ISSUE NO. : 09-003	DATE : 4th Mar. 2009	PAGES : 1 OF 2
--------------------	----------------------	----------------

SUBJECT	Tensioner, Adjuster improvement
MODEL	GT/GV-125/250
EFFECTIVE F/M NO

3. Marking on products

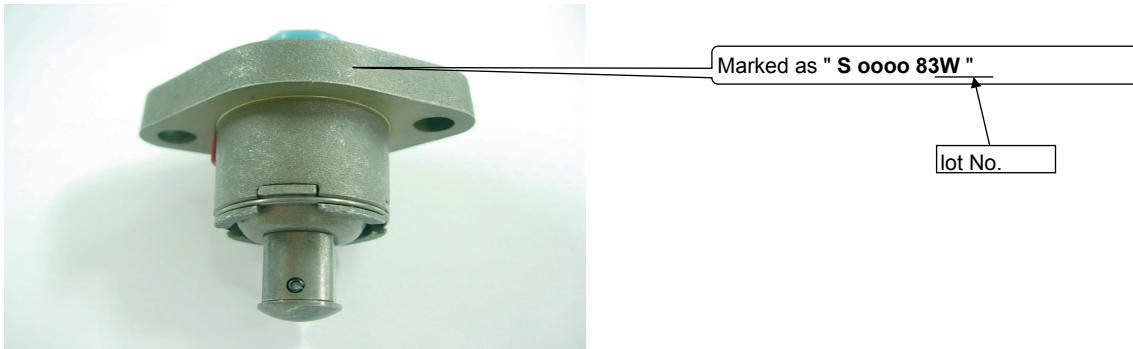
This service bulletin is written to inform you that Tensioner, Adjuster got improvements
